CITY OF
JOHN DAY

CITY COUNCIL MEETING AGENDA

8. Public Hearing: (file# SDR 24-01)
   The Oregon State Parks and Recreation Department (OPRD) is requesting Site Design Review for the new construction of the Kam Wah Chung State Heritage Site and Interpretive Center. OPRD also requests the vacation of two historic easements on the site; a historic setback and a waterline easement that is no longer needed. This application is being elevated to a type IV land use review. The Planning Commission recommended approval with conditions:

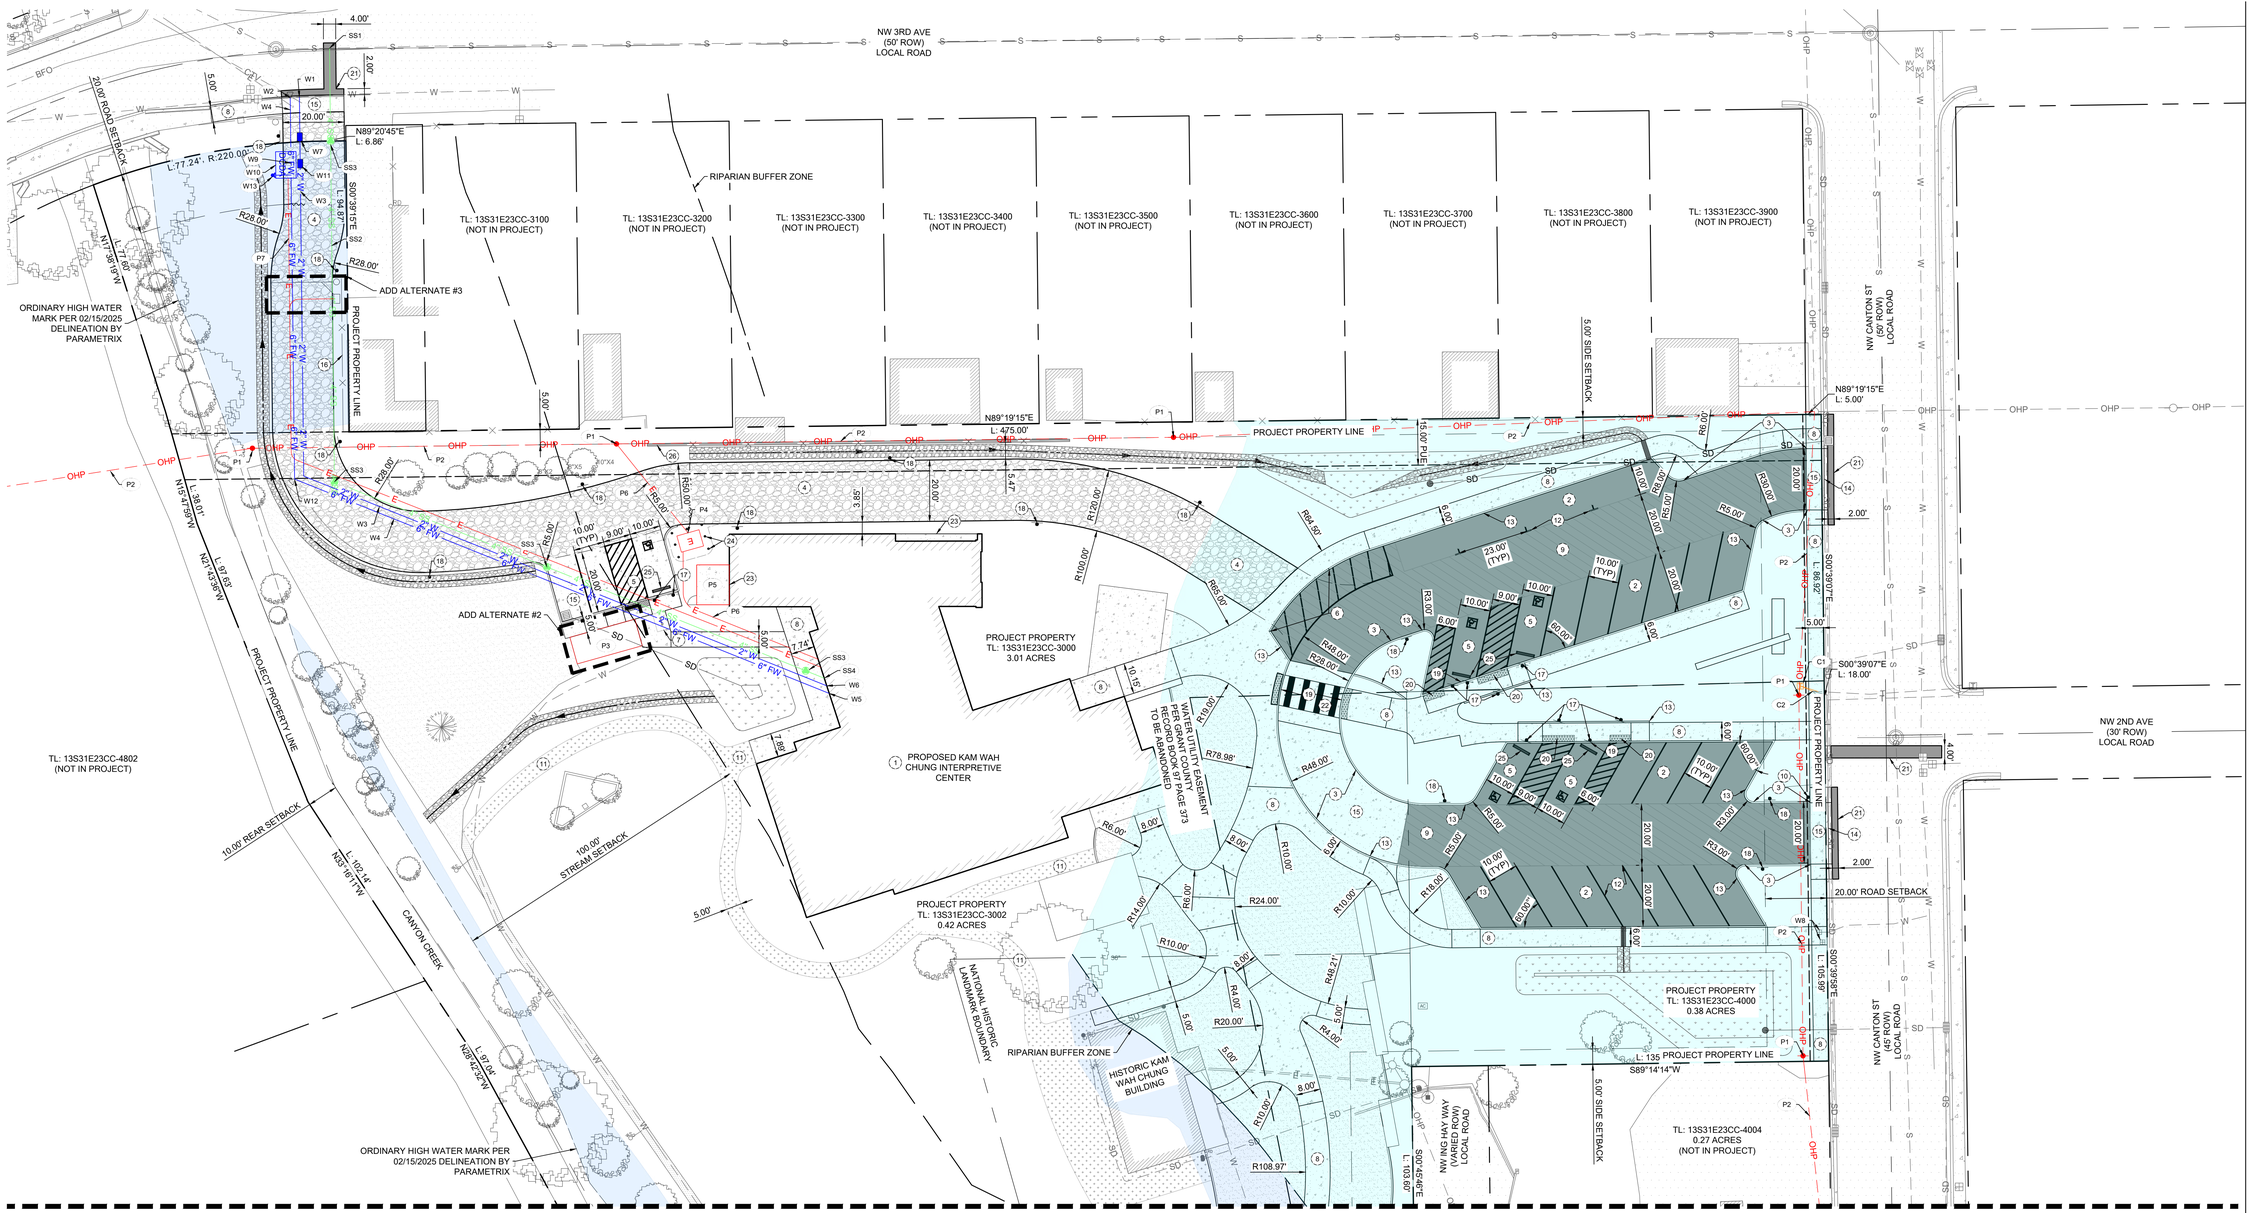
Staff Response: The subject property is zoned Park Reserve (PR). As shown on Sheet C-2.0, the new KWC maintains the following setbacks:

Staff Response: As shown on Sheet C-2.0, a looped one-way driveway is proposed from NW Canton Street. The entrance taper at NW Canton Street is 20 feet, widening as vehicles enter the one-way driveway to access parking. While the 20-foot wide driveway meets fire code standards, it does exceed the maximum stated width of 12 feet per lane. However, this 20-foot width is necessary for fire access and to accommodate RVs and buses for large groups, such as tour groups and schools, visiting the site.

Staff Response: As shown on Sheet C-2.0, the driveway approaches provide an unobstructed view of other vehicles and pedestrians. Furthermore, the traffic generation memo prepared by the applicant's traffic engineer recommends constructing concrete "dustpan" driveway aprons at the reconstructed access points on NW Canton Street and NW Ing Hay Way. It also suggests replacing the rolled curb on NW Canton Street with standard curbing to prevent parked vehicles from encroaching onto the sidewalks. These recommendations from the traffic engineer will be implemented as conditions of approval for Site Design Review. Please refer to **Exhibit D** for the revised traffic generation memo.

the site plan;	are included. Setbacks are shown. **Water/sewer utilities** show location only (no size/dimension) and plans indicate two alternative alignments for the water service and fire line (Sheet C-2.0). **Applicant should perform a utility exploration "pothole"** to confirm existing pipe sizes and materials. City has indicated a preference for water service to be provided from NW Canton St. The applicant's potholing should also seek to determine if a tee exists at the existing 2-inch water main and if it could be used for connection. Applicant shall obtain a ROW permit prior to potholing. The property has frontage on NW 3rd Ave, NW Canton St, and NW Ing Hay Way. Sidewalk improvements are indicated on NW Canton and only a portion of NW Ing Hay Way (northwards from the proposed parking lot). (Sheets C-2.0 and 2.1.) **It is recommended that the City require sidewalk improvements on the full width of NW 3rd Ave and NW Ing Hay Way frontages** in accordance with JDDC § 5-3.4.010.A.3 and Table 5-3.4.010F Option D.

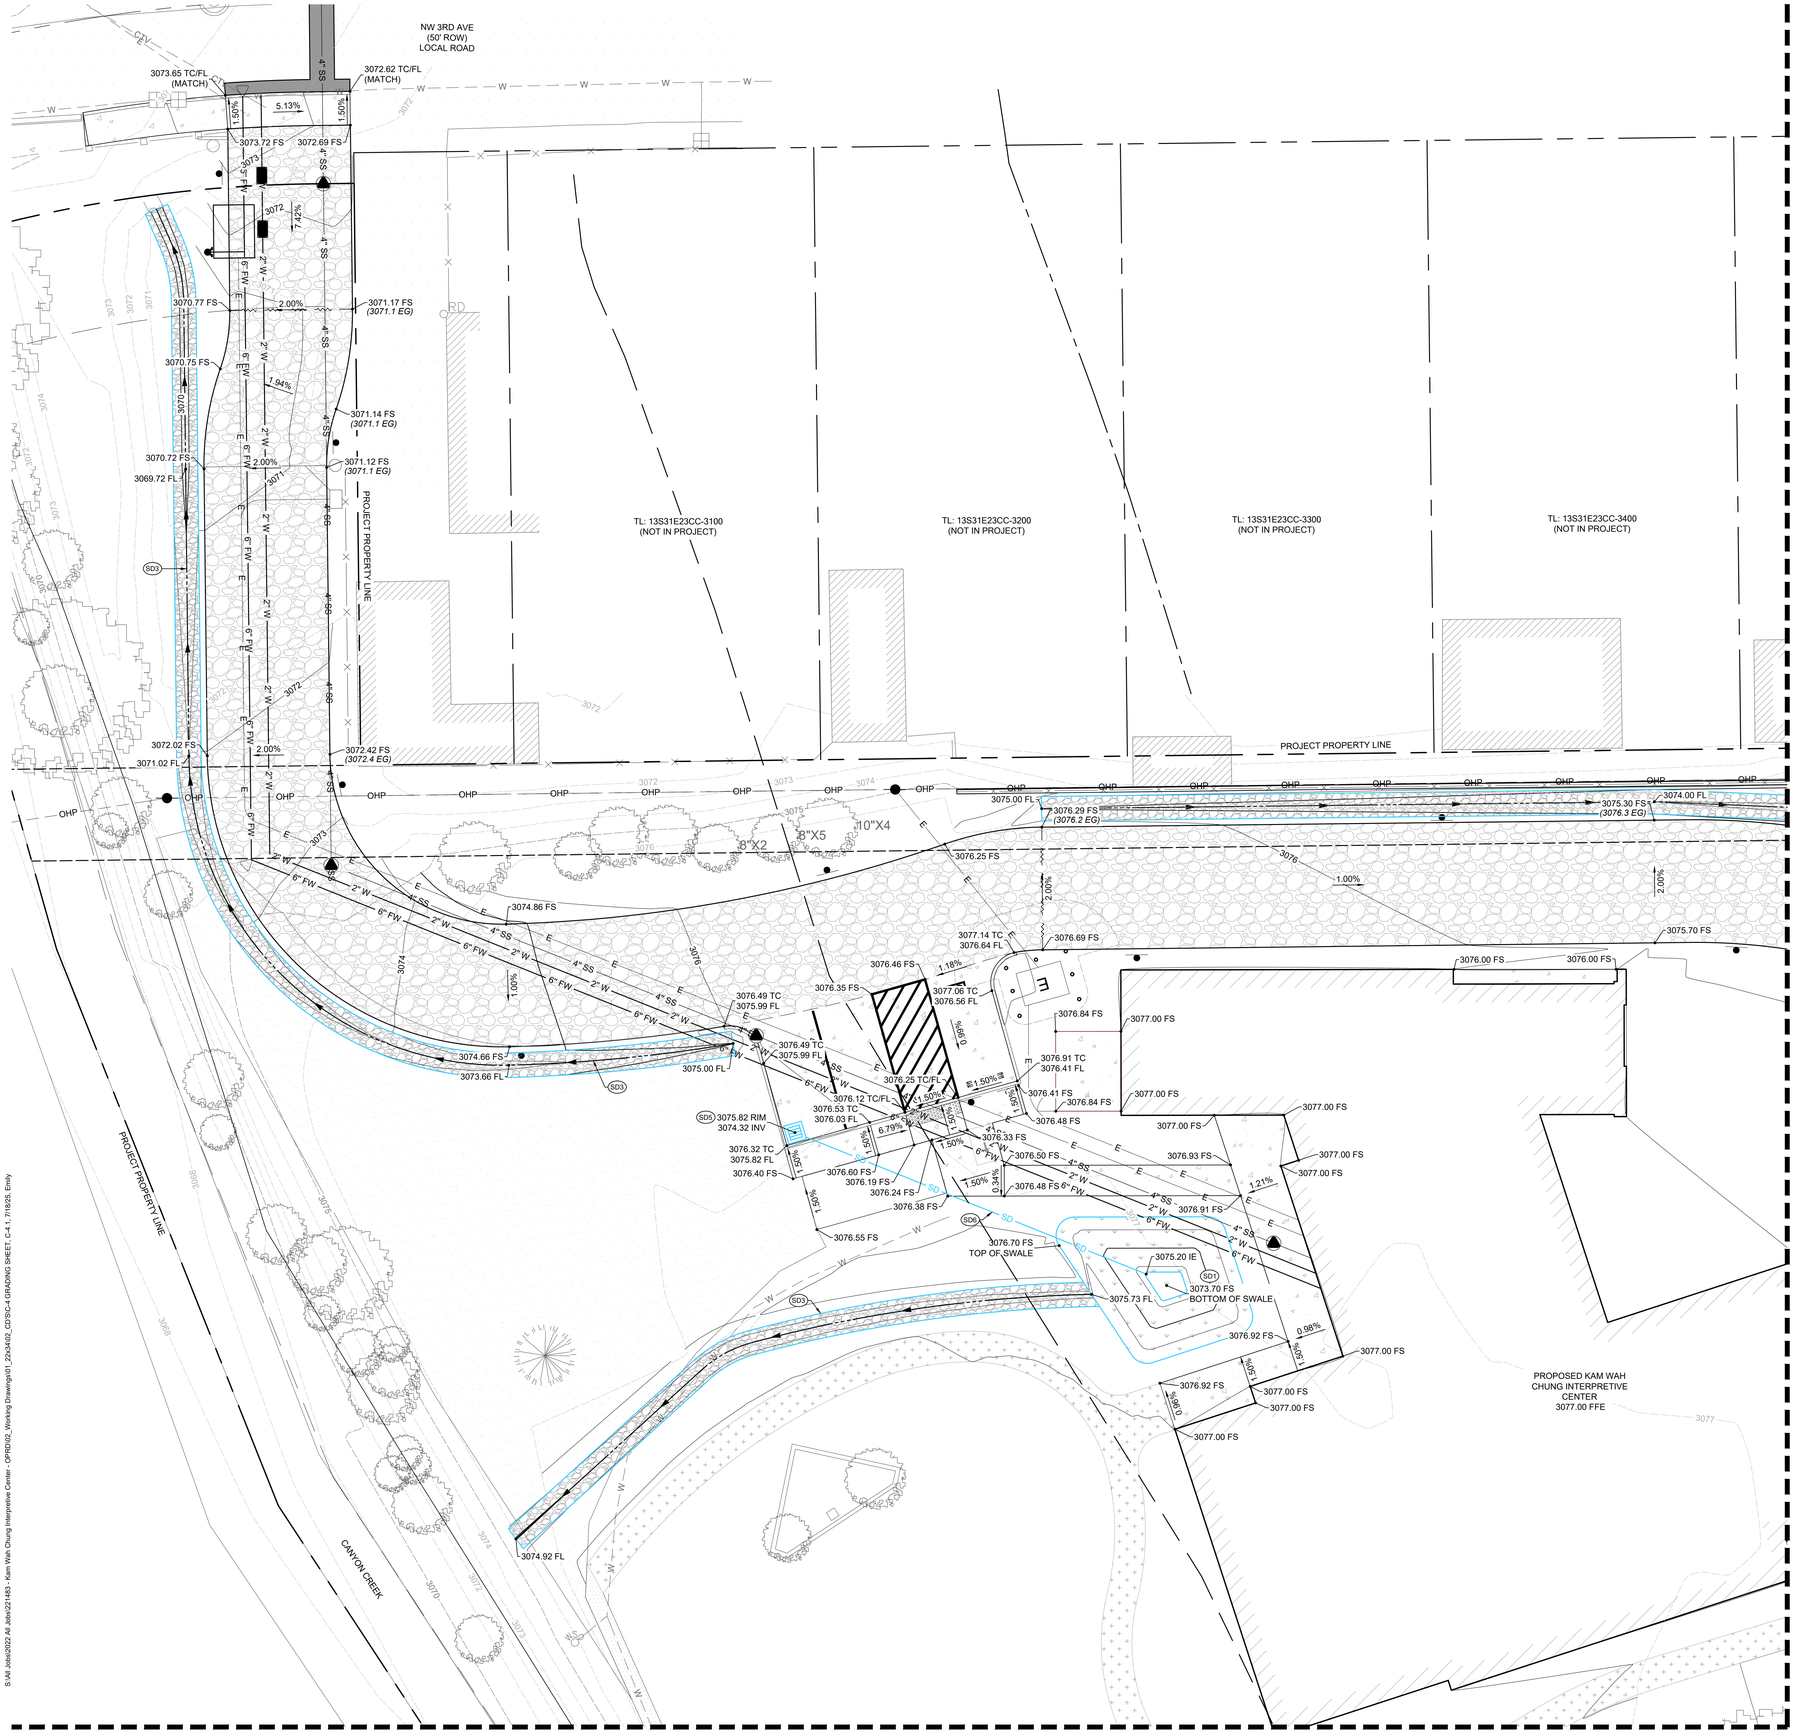
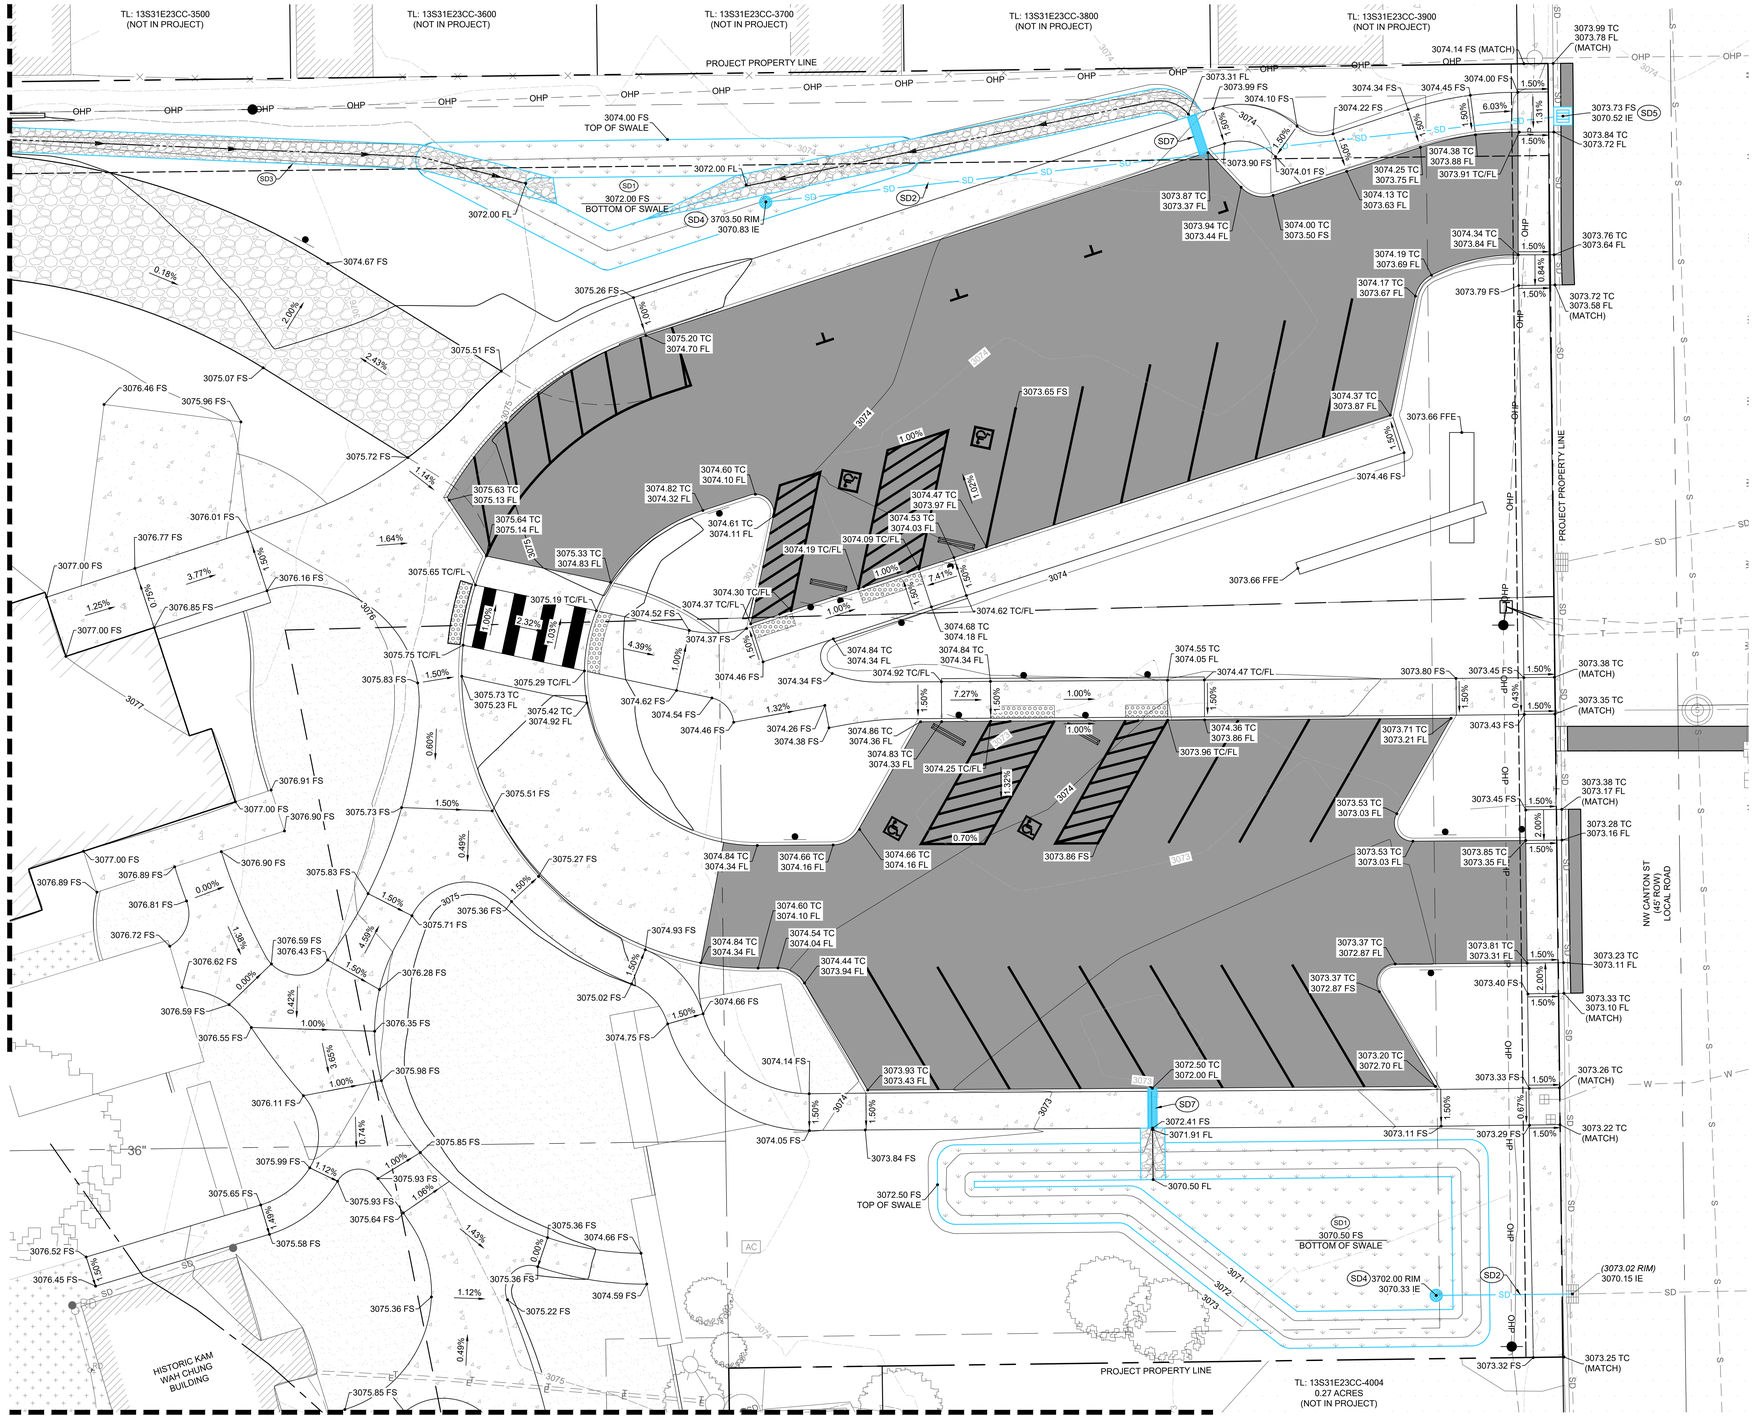
Staff Response: The applicant's civil engineering firm, Ashley & Vance, submitted a grading and drainage plan as shown on Sheets C-4.0 and C-4.1 (**Exhibit A**). The preliminary grading and drainage plans have been reviewed by the City Engineer. The site will include three swales to manage stormwater drainage. Swale 1 will be located at the northern end of the site, adjacent to the entrance from NW Canton Street. Swale 2 will be situated to the rear of the new museum, and Swale 3 will be

Staff Response: The project does include new stormwater drainage facilities. Refer to applicant's drainage plans on Sheets C-4.0 and C-4.1, as well as a stormwater drainage study completed by the applicant's engineering firm. The applicant's preliminary stormwater drainage plans have been reviewed by the City Engineer and have undergone several revisions. At this time, the plans are acceptable for Site Design Review. Further and more detailed review will occur as part of building permit review when the applicant completes a full set of detailed engineering plans.
